## Development Engineer Referral Response

DA-2022/237

Integrated Development - Demolition of existing structures and construction of a seven (7) storey mixed-use development comprising retail uses, hotel accommodation, food and drink premises, roof-top recreation, basement carparking and tree removal  
277 The Grand Parade RAMSGATE BEACH NSW 2217

### **Function Centre:**

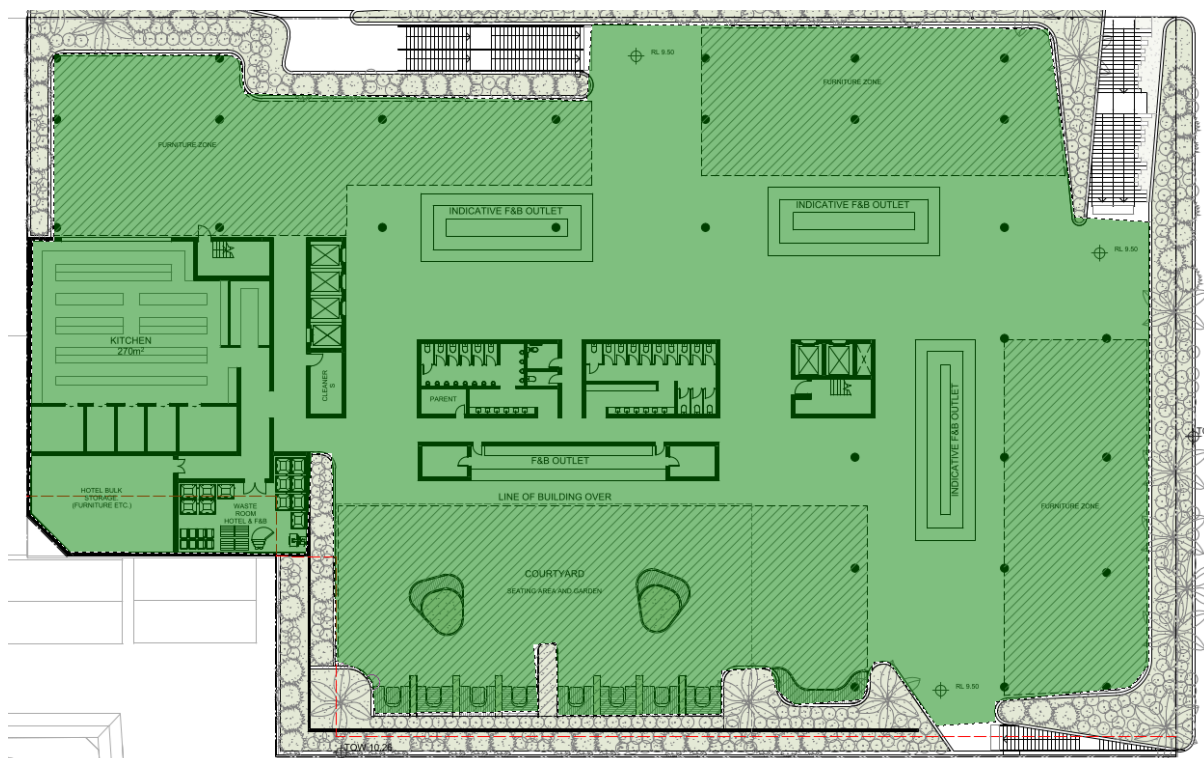
The traffic report indicates that the function centre is an ancillary aspect to the hotel. This has been favourably considered for small function centres in the past that are essentially “meeting rooms”. See DA-2019/233 which approved 163m<sup>2</sup> GFA of ancillary “meeting rooms” spread over 4 rooms and DA-2021/450 which approved 101.8m<sup>2</sup> GFA of ancillary “meeting rooms” spread over 3 rooms. These two DA’s are located in a highly accessible area and it was agreed that the small function rooms were ancillary to the hotel, therefore no additional parking was considered necessary.

In contrast this development is in an inaccessible area and proposes a very large (340m<sup>2</sup>) function space in a single room (with a large outdoor function area adjacent), which is considered to be extensive enough to not be considered an ancillary aspect to the hotel. Therefore, it is not considered to be ancillary to the hotel and will generate its own separate demand for parking.

The Rockdale Development Control Plan (2011) specifies the parking requirement for function centre shall be in accordance with the function room parking rates outlined in the RTA Guideline to Traffic Generating Development 2002. The RTA guide to traffic generating development doesn’t have a parking rate for a function centre so a parking study is necessary to determine the parking demand for the function centre.

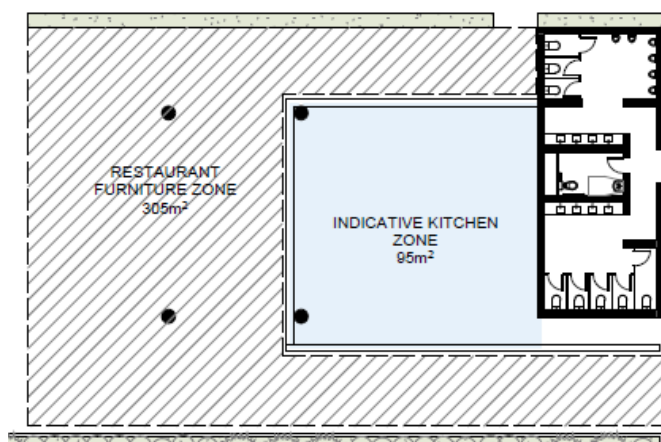
The Rockdale Development Control Plan (2011) specifies the parking requirement for retail premises at 1 space per 40m<sup>2</sup>. On the ground floor there is a total of 339m<sup>2</sup> of small shops GFA and 2920m<sup>2</sup> of supermarket GFA. On level 1 & 2 the restaurant/food and drink premises extent is not clear, the traffic report quotes two numbers of 1800m<sup>2</sup> for F&B (Food and beverage?) and 705m<sup>2</sup> for restaurant, its not clear how either of those numbers was calculated. On level 1 it is considered that the whole level (3663m<sup>2</sup>) is used for the purposes of a food and drink premises (shown below):

There is also a 400m<sup>2</sup> restaurant proposed on level 2:

Food and drink premises isn't directly given a parking rate in the DCP however, it forms part of the retail premises definition in the LEP and hence is subject to the retail premises parking rate in the RDCP (1 space per 40m<sup>2</sup>).

***VEHICULAR ACCESS DESIGN & COUNCIL CAR PARK - VPA:***

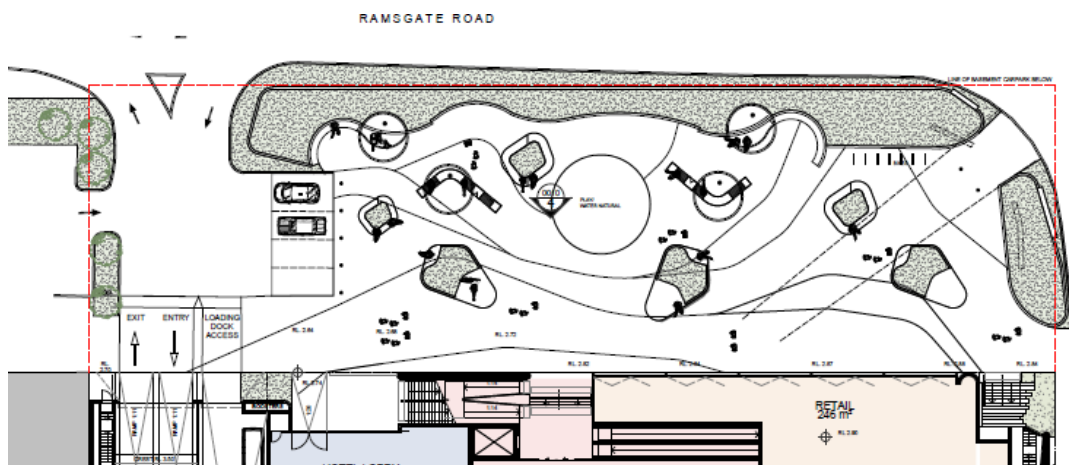
### Potential VPA:

- There is potential for a VPA to be executed between the developer and council to convert the frontage of the site from at grade parking to an open plaza with two levels of parking provided within public land for council to use. This would increase the parking provision from approx. 200 spaces to approx. 400 spaces.

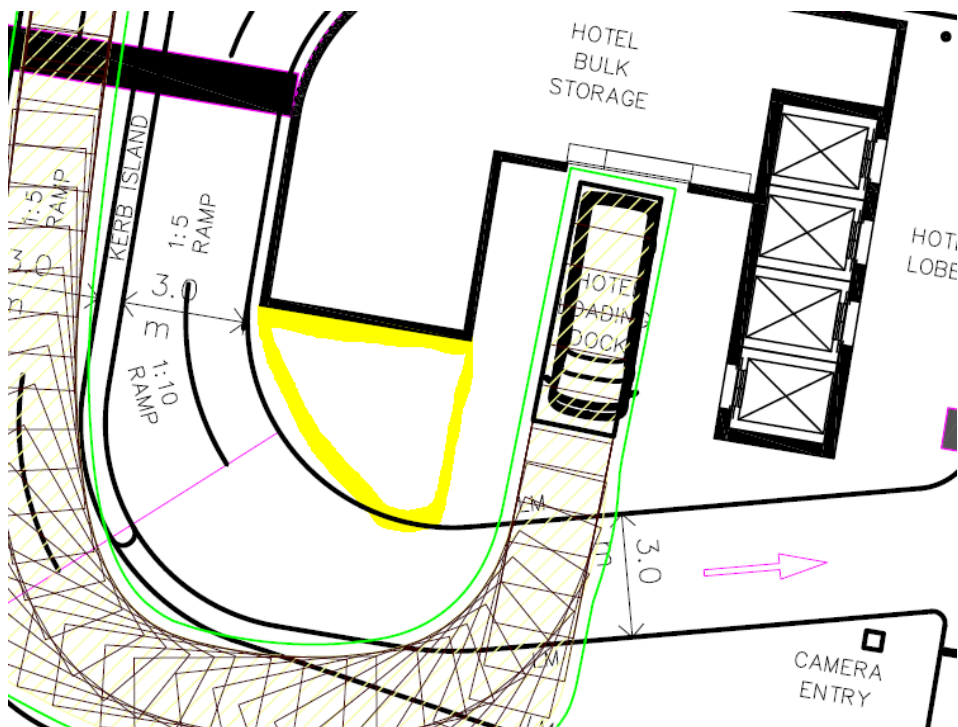
1. B2 (and B1) – Disabled car spaces make sense for shoppers – what about 2 for hotel – should be close to the hotel lobby lift rather than Coles? Shouldn't southern ones on B2 be flipped to the north? (E)

The applicant has deliberately separated the car park into two distinct portions retail premises/food and drink premises parking & Hotel parking (the two distinct parking areas will be separated by boom gates on B2 so the general public cannot access the hotel parking spaces). This is the reason why the 2 hotel accessible spaces are located so far away from the hotel lobby.

The two hotel van loading spaces on basement level 2 do not appear to have much purpose (the hotel already has a van loading space proposed on b1) so these could be converted into accessible parking space(s) for the hotel to provide accessible parking spaces in close proximity to the lift.

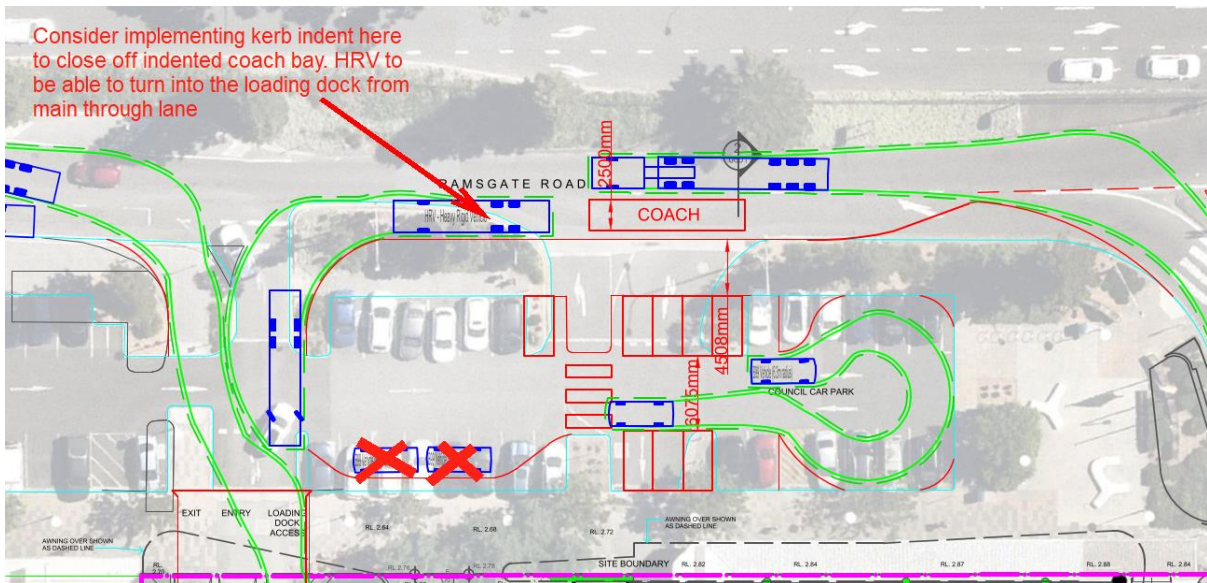
It is noted that the BTDAC comments were not addressed in the amended road design submitted to Council:

Furthermore, given Ramsgate Road is a Classified Regional Road and The Grand Parade is a classified State Road, approval from TfNSW is required for all works to the road reserve fronting the site. This approval has not been obtained and given the late submission of the traffic report, no time was available to send a referral to TfNSW to obtain their concurrence.

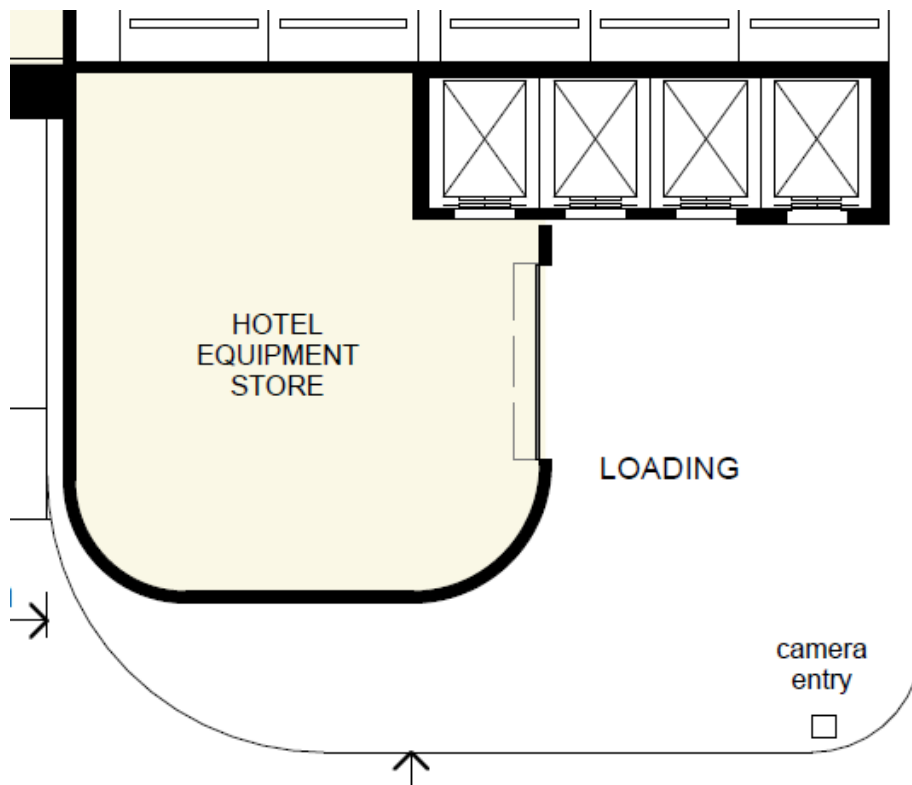
The engineering comments made on 25/09/2023 (23/275608) were not fully addressed.

The loading for the hotel still occurs in front of lifts which is not a good outcome.
